Interactive comment on "Substantial meltwater contribution to the Brahmaputra revealed by satellite gravimetry" *by* Shuang Yi et al.

Received and published: 3 February 2020

Fig. 1. Contribution of various components to streamflow in the Brahmaputra

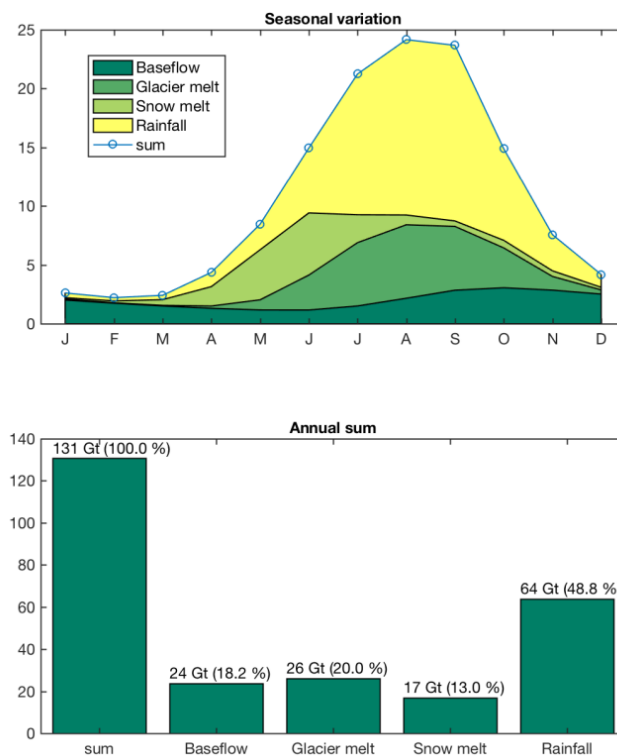
Page 2: Line 40: (Table 1): Glacier and snowmelt contribution to the total discharge of Upper Brahmaputra river basin is 34% from Lutz et al. 2014 in Table 1. Whereas, Lutz et al. 2014 have indicated the contribution to a total runoff as 24.9% (15.9% from glacier melt and 9.0% from snowmelt: Table S3: Basin characteristics). I am not sure where 34% have come from. Please check this.

Line 9: 301: 33% of GS melt contribution in Brahmaputra river. It is 34% in Page 1, Line40. Please see my first comment in the major comment section

The authors kindly provided us the monthly runoff data, as shown below (y-axis in Gt, or km^3). I wrote to the authors to inquire why this discrepancy happened, and I was told that 24.9% is the result for Brahmaputra with several tributaries (the red area in fig. 2, from Fig. 1 of their paper). Therefore, the value of 34% is correct here.

We are sorry for the typo. It should be 33% , as you may find in the figure above.
